APPROVED  
 BLDG DEPT.  
 CITY OF ALTA MONTE SPRINGS, FLA  
 DATE: 7/21/91  
 BLDG OFFICIAL: [Signature]  
 FIRE OFFICIAL: [Signature]  
 PERMIT NO.: 8584-81  
 ADDRESS: 300 [unclear] Rd  
 THIS APPROVAL DOES NOT GRANT PERMISSION TO VIOLATE ANY APPLICABLE CODE. KEEP THIS PLAN ON JOB AT ALL TIMES.

FLOOR PLAN  
SCALE - 1/4" = 1'-0"

INTERIOR CHANGES

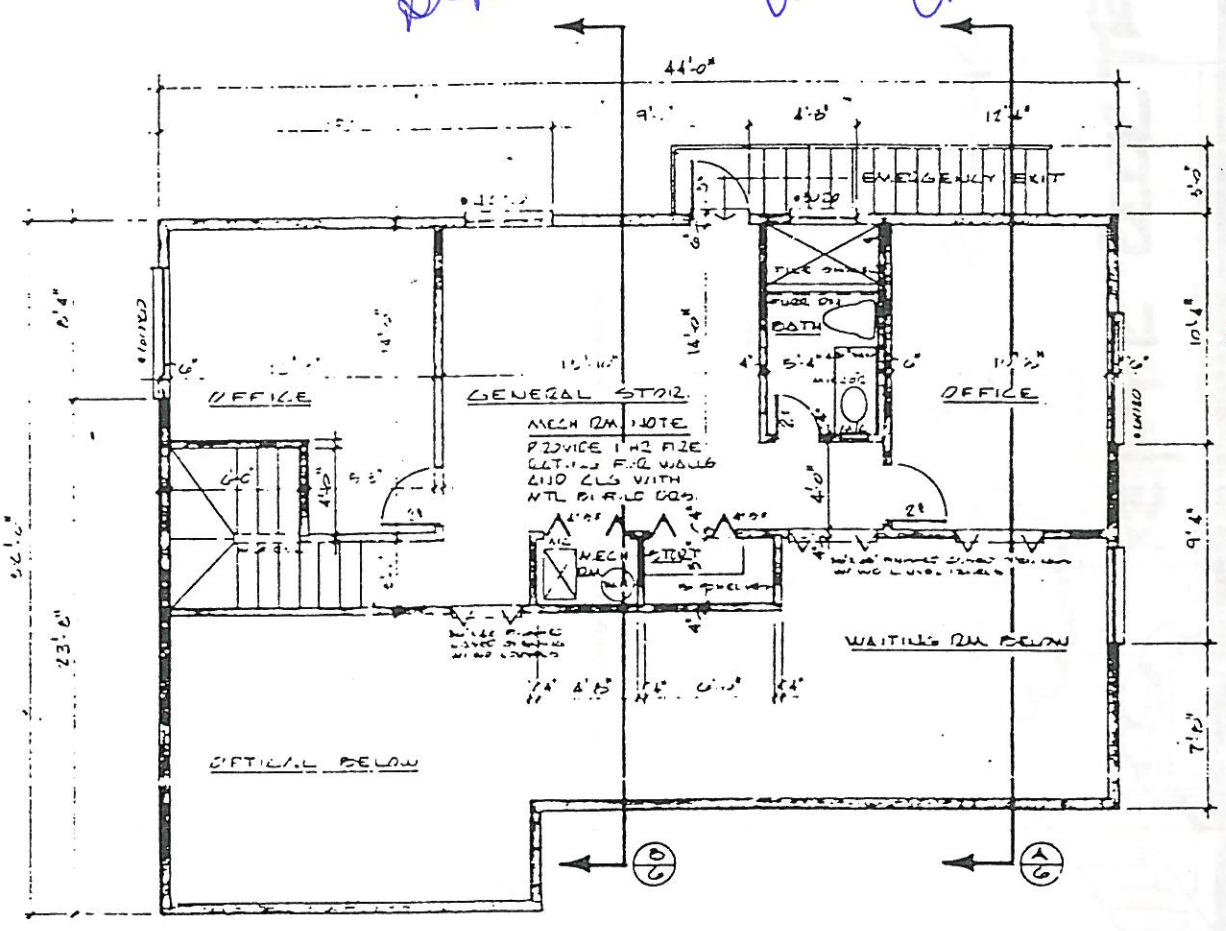
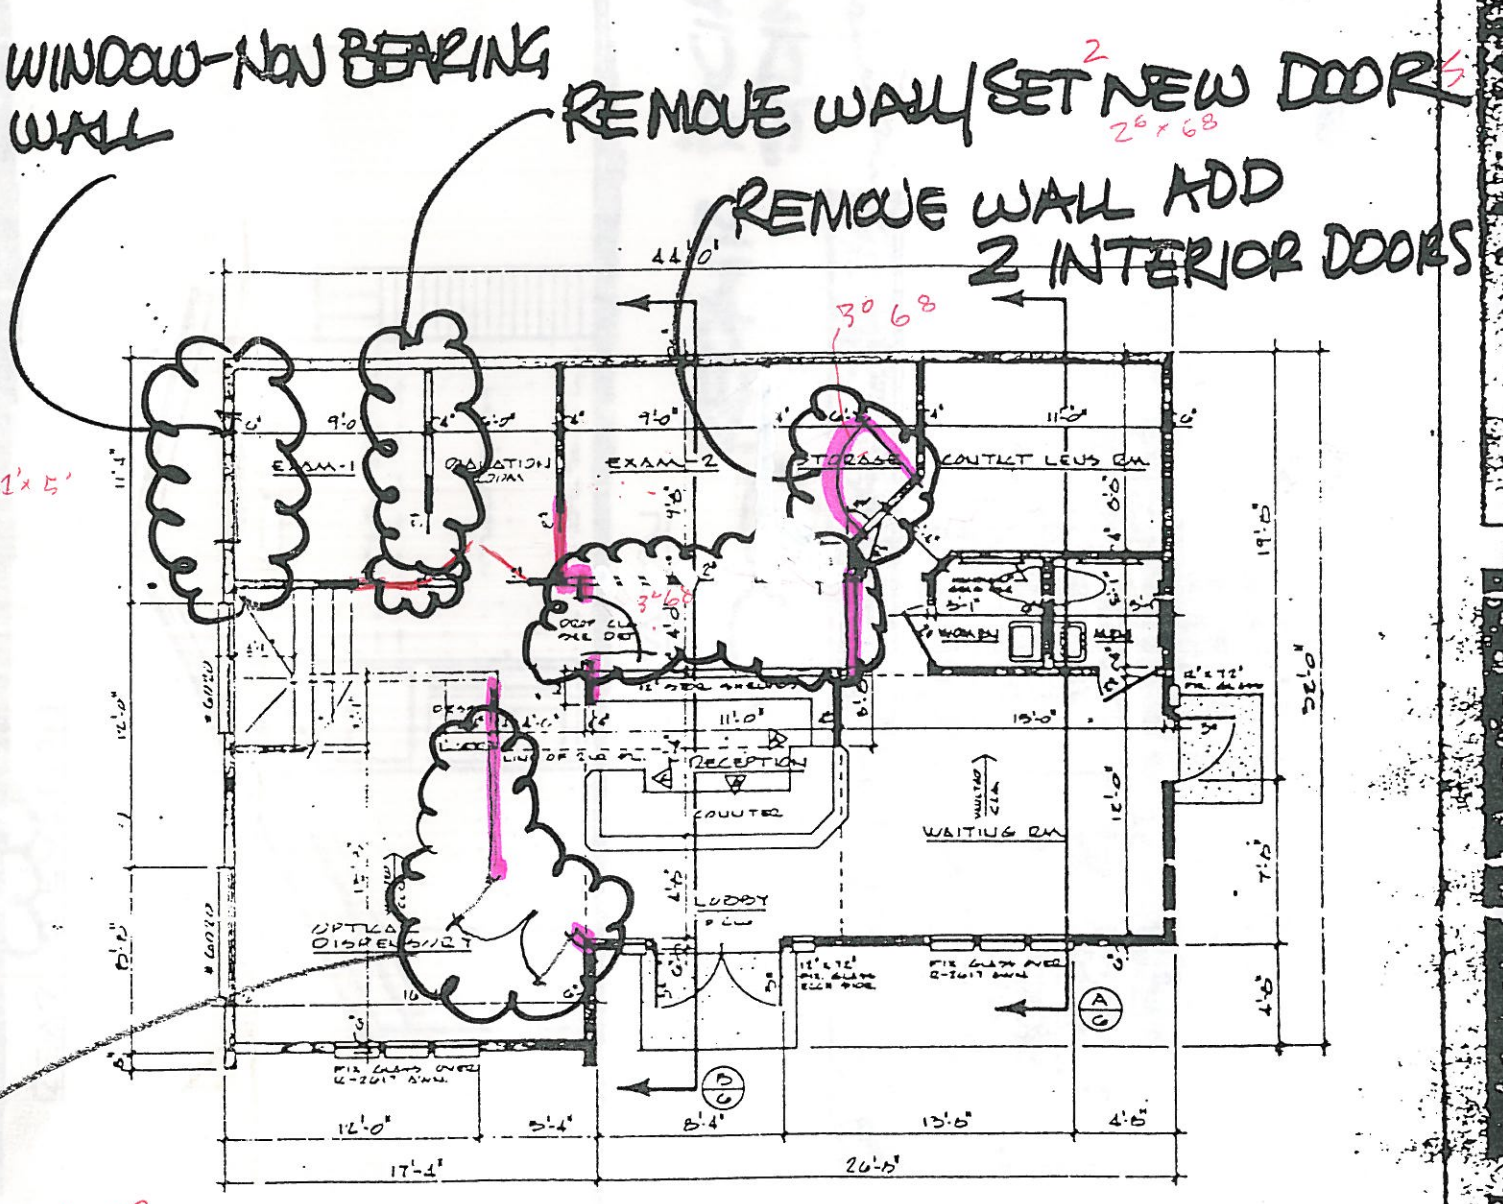
Please call & schedule final elect insp. & final pdg. insp. separately from building insp. call 8/20/99

NOTE: SIGN PERMIT  
REQUIRED

SOIL POISONING  
REQUIRED

INSULATION INSPECTION  
REQUIRED  
AFTER FRAME
